THE CLEVELAND ELECTRIC ILLUMINATING COMPANY

Perry Nuclear Power Plant
Docket Nos. 50-440; 50-441
Revised Responses -
Draft SER for
Structural Engineering Branch

Response to NRC Question 35

PERRY NUCLEAR POWER PLANT
FHB/IB FLOOR RESPONSE SPECTRA
ELEV 707'6" SSE .01 DAMPING
JT NO 80 (XT) NORTH-SOUTH

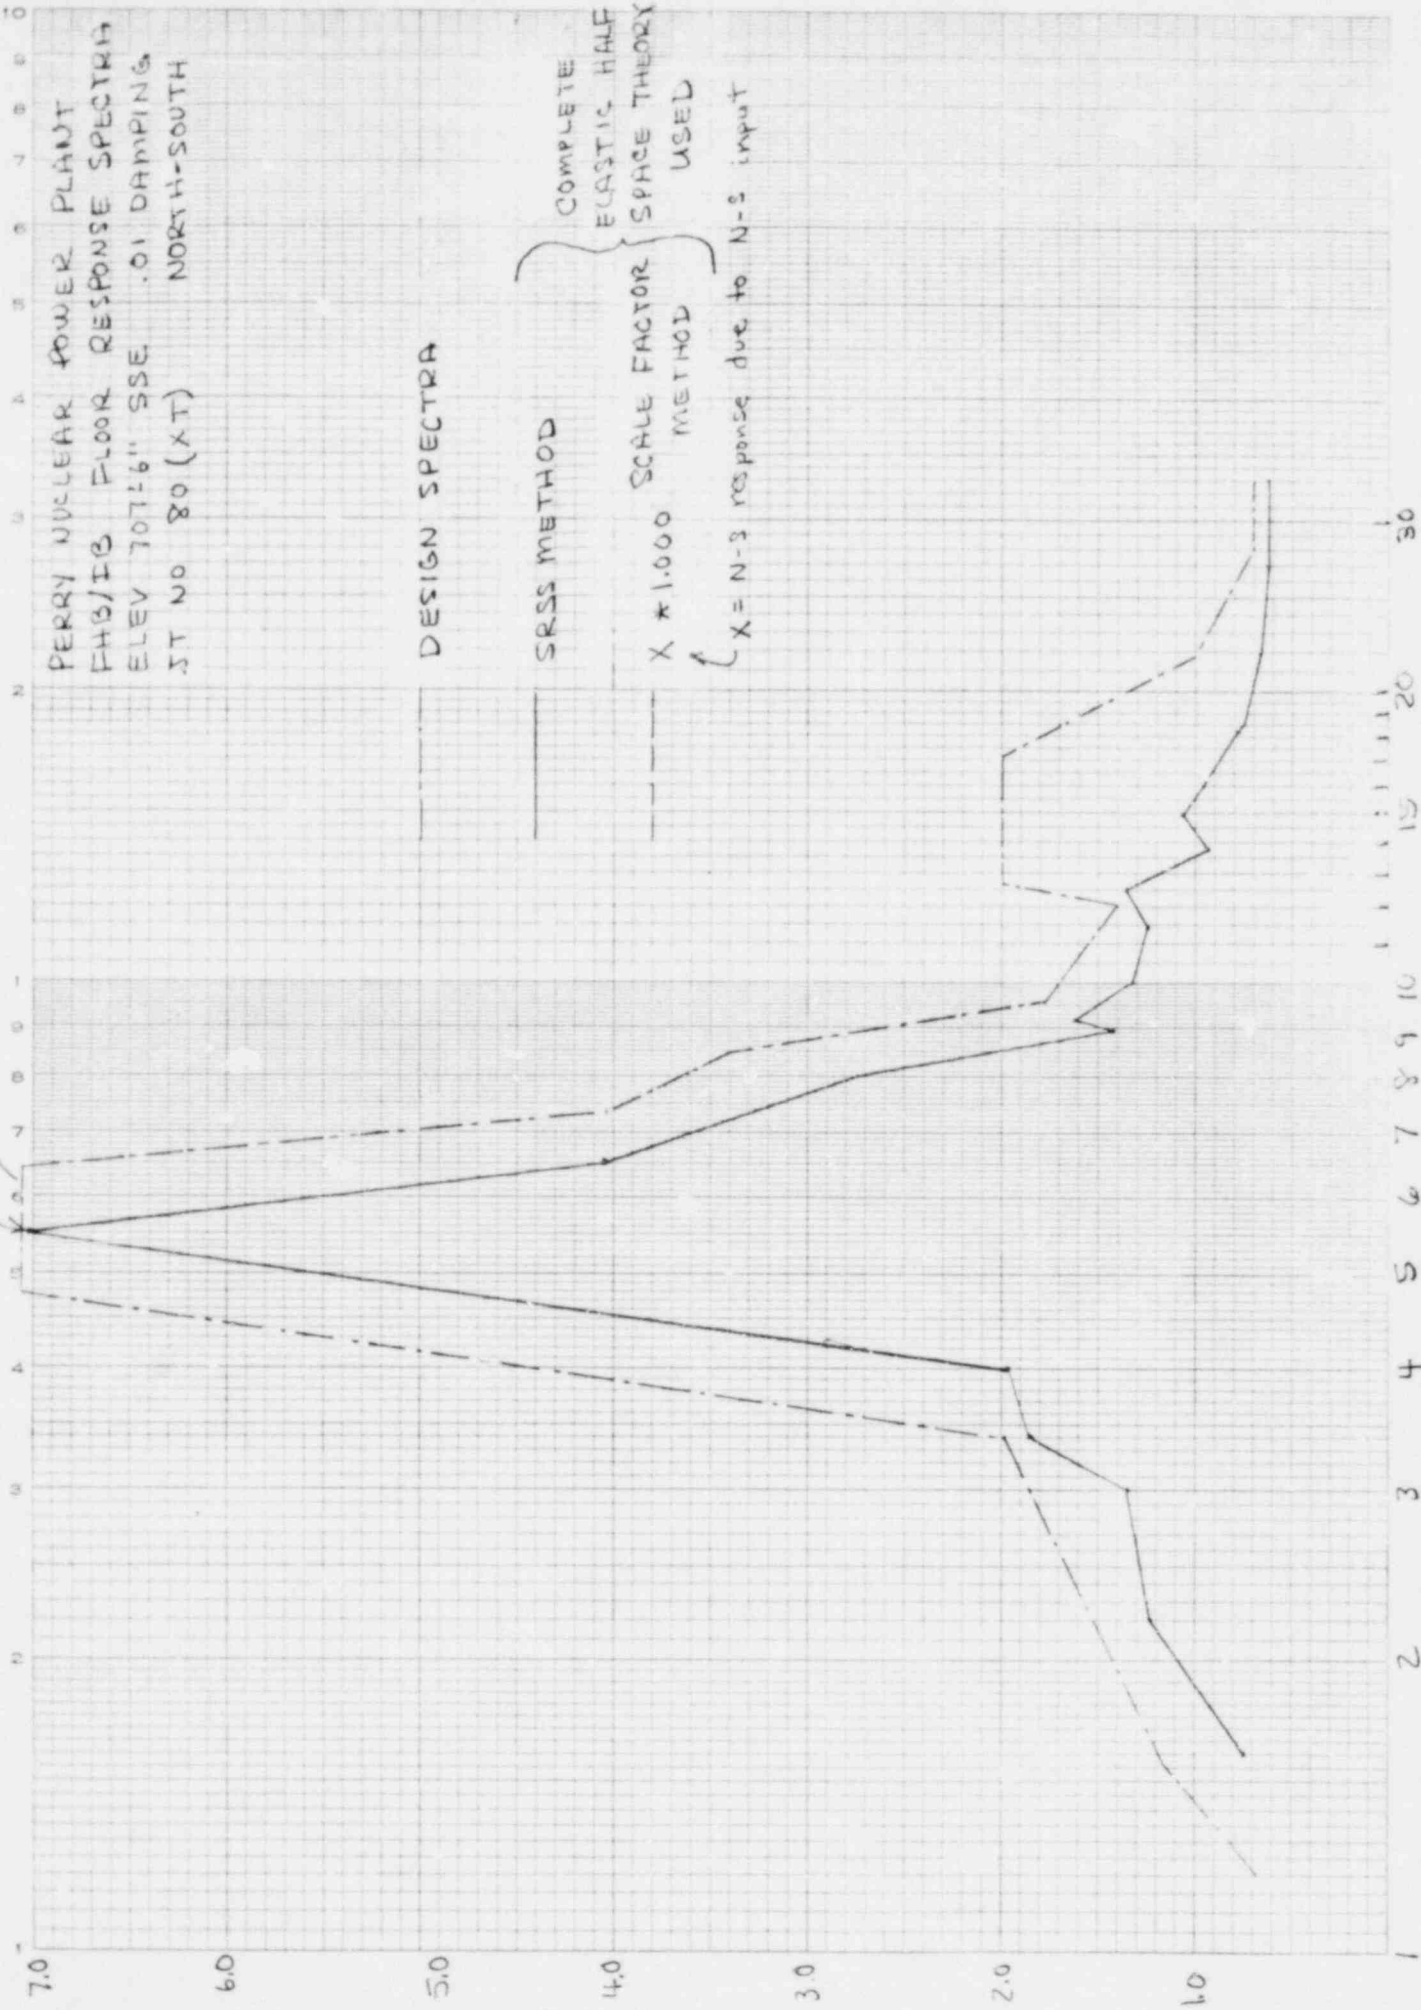
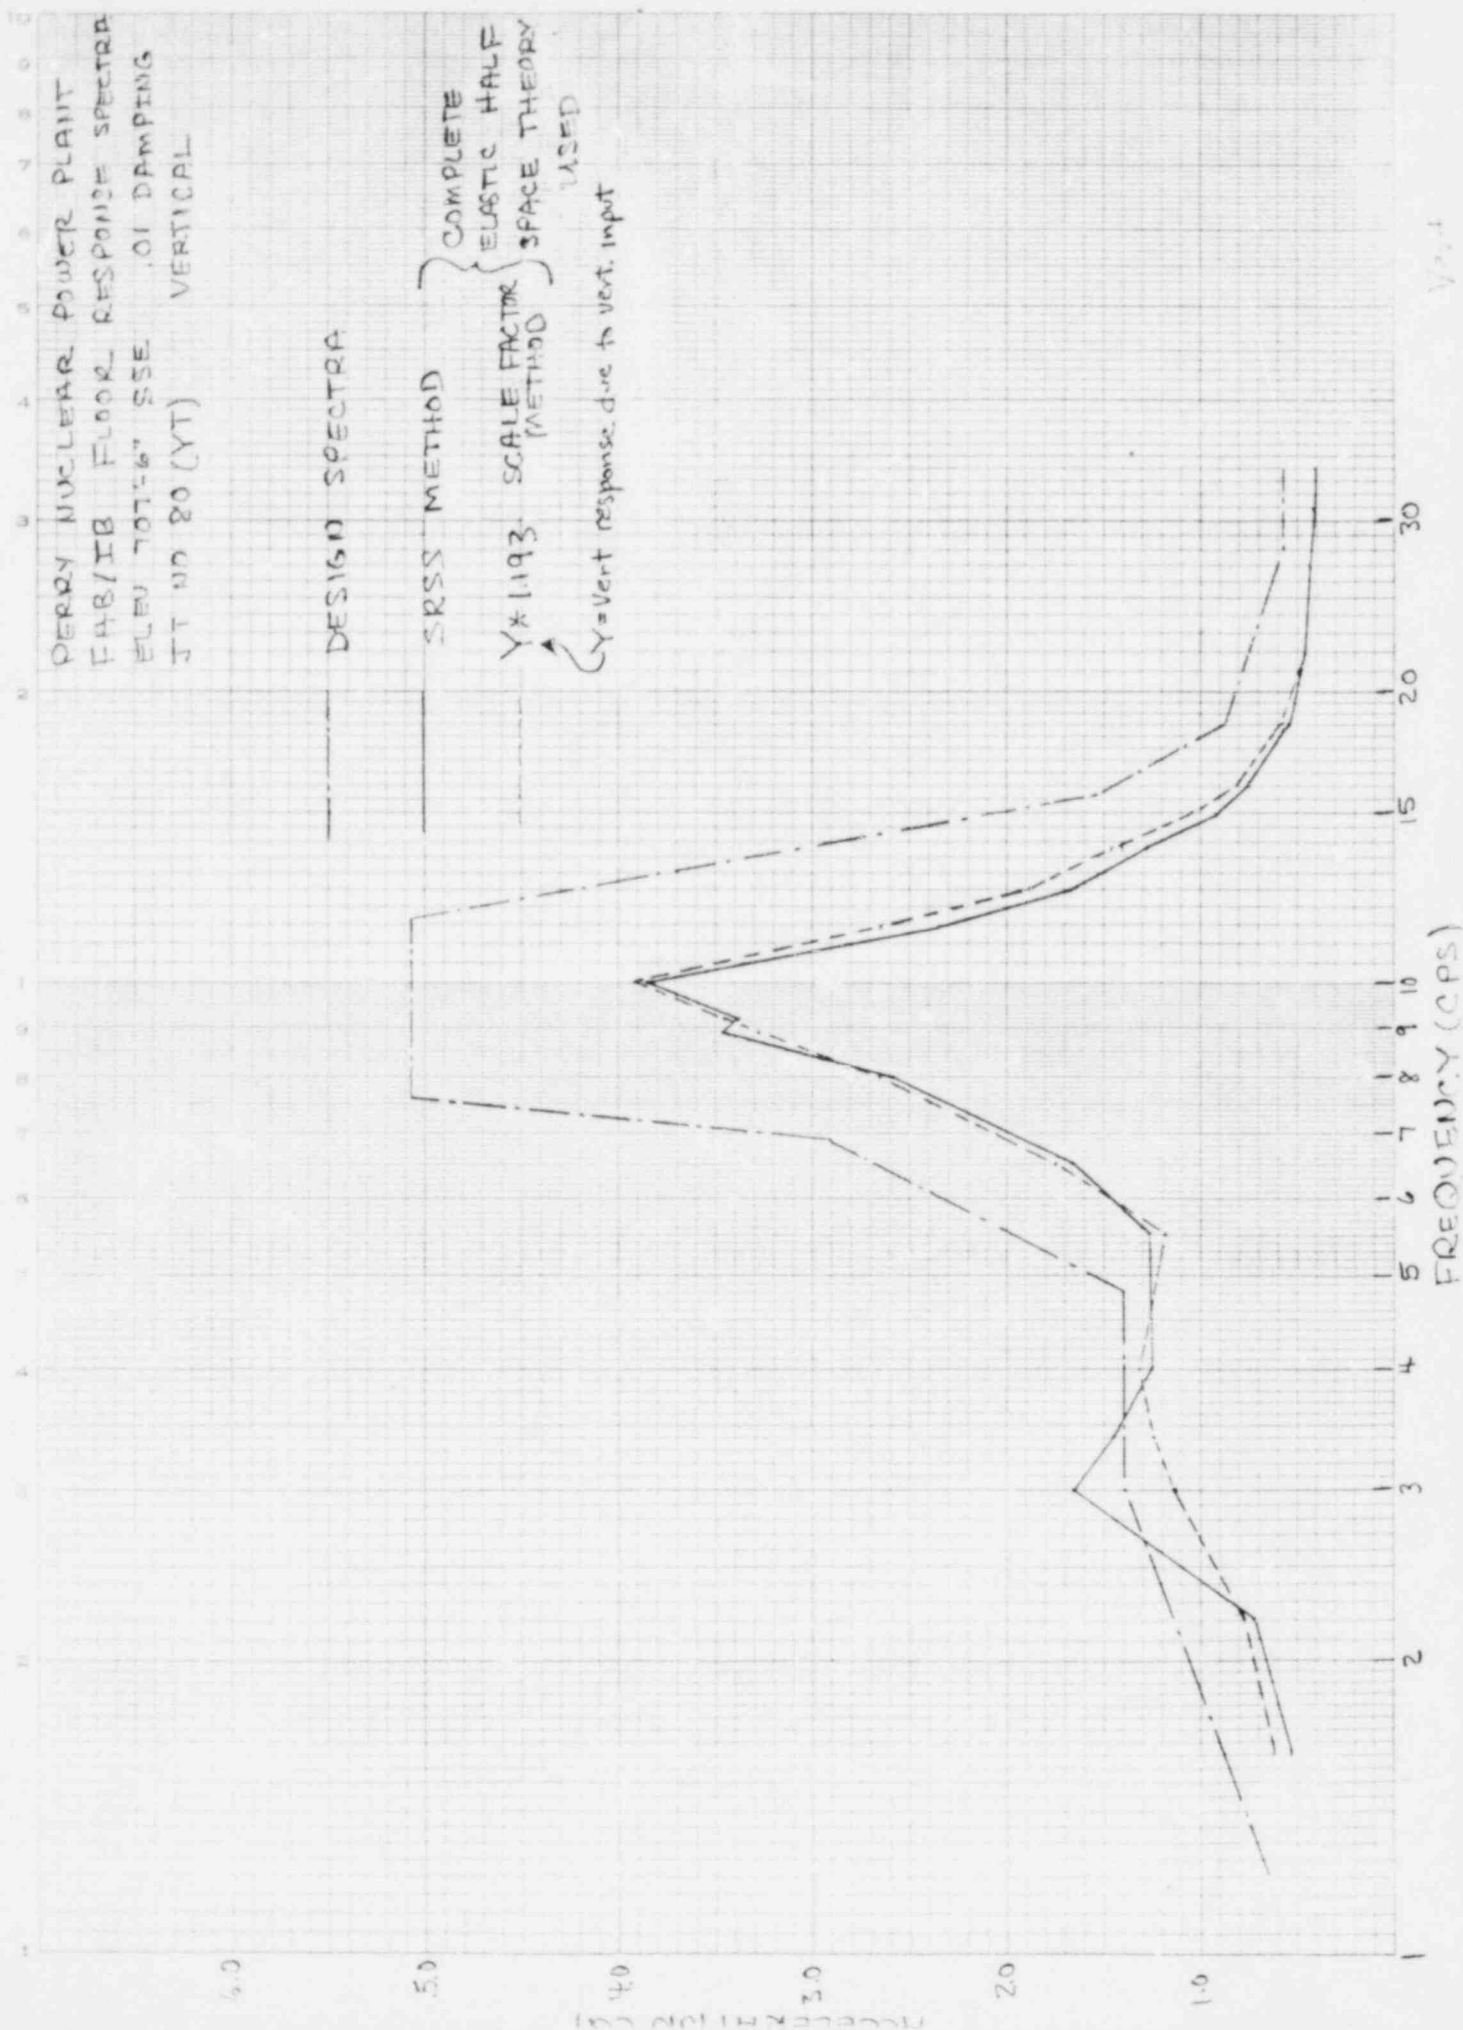
Since the Intermediate/Fuel Handling Building is a flat and massive structure, the coupling between horizontal and vertical responses is minimal. Consequently, the response spectra scaling method is justified. To confirm the above, the comparison of scaling method and SRSS is as shown in the attached figures. They are very close to each other and all within design spectra by a large margin except a few small isolated areas.

In conclusion, the existing design spectra are still considered adequate for seismic qualification. The close agreement of the response spectra considering the different methods of combining the 3 earthquake input directions indicates a valid approach. The two instances of localized small experience are not considered to have any practical design impact.
